**From:**Scott Nicholas  
**Sent:**Mon, 25 Jan 2021 13:14:39 +0000  
**To:**General Planning Enquiries  
**Cc:**Helen Frith  
**Subject:**Conservation Officer comments - CHE/20/00869/REM

***RE: CHE/20/00869/REM: Approval of reserved matters for 150 dwellings of CHE/18/00532/OUT ( Re-submission of CHE/16/00614/OUT). Outline application for proposed housing development with all matters reserved except the access, Land To The North Of Northmoor View Brimington.***

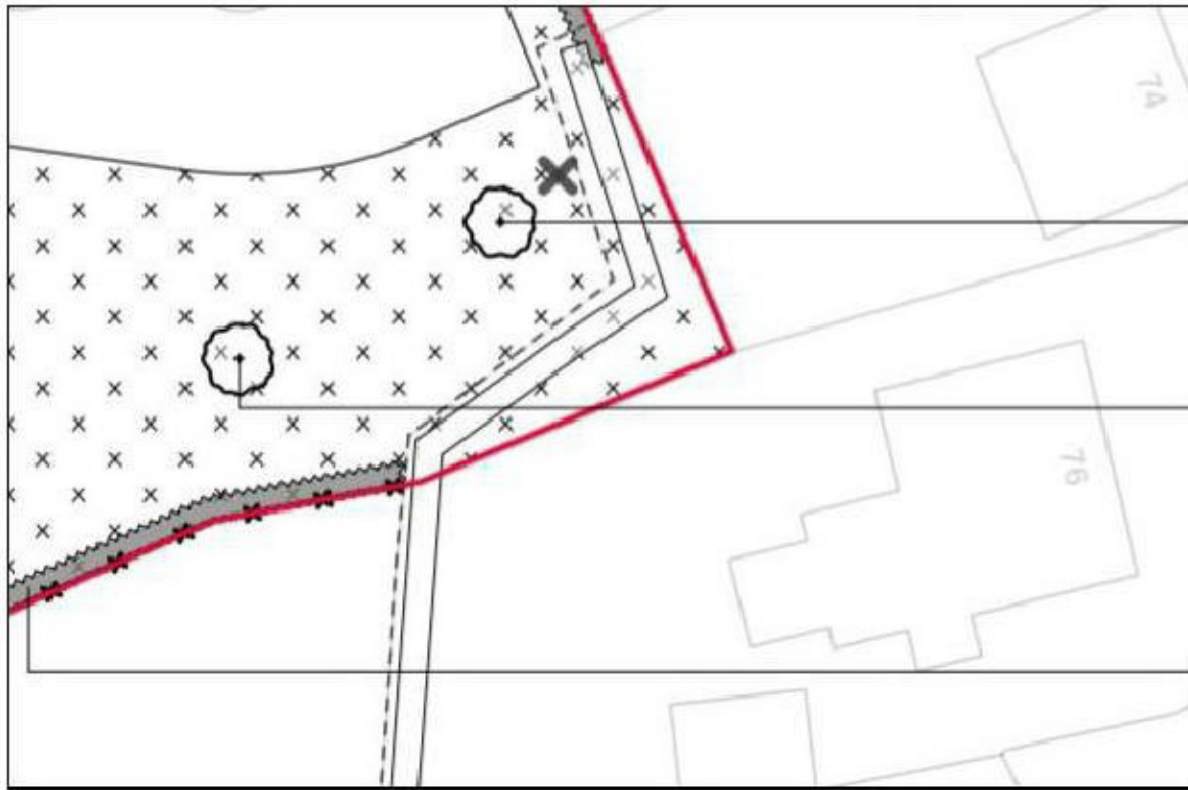
This reserved matters application shows what could be considered a buffer zone between Manor House and the proposed new development (ref: Landscape Proposals 8881-L-102B). This area would be made up of 'amenity grassland' interspersed with 'sorbus Joseph Rock', 'prunus padus' and 'log piles (for biodiversity benefit). This grassland area; the rear garden of Manor House; and the proposed access road servicing the new houses, would when considered together, provide a fairly significant amount of open space to mitigate any impact on the setting of the grade II listed building. The design of the proposed houses to the west of Manor House would reflect neo-traditional volume house builder styles (i.e. 2-storey brick construction with pitched/gables roofs and some detailing and features around windows). The boundary treatment of the amenity grassland would, according to the Landscape Proposals, be 'post and rail fence'.

On this basis I have no objection to what is being proposed. My only recommendation would be to get more clarity about the exact type, size and extent of the proposed boundary treatments to the west of Manor House. Whilst the applicant has provided a Boundary Treatment Strategy (contained within the Landscape Strategy) it doesn't appear to show for instance the type of post and rail fence being proposed. Below is a snapshot taken from the applicants Landscape Proposals map showing the area I would be most concerned about:
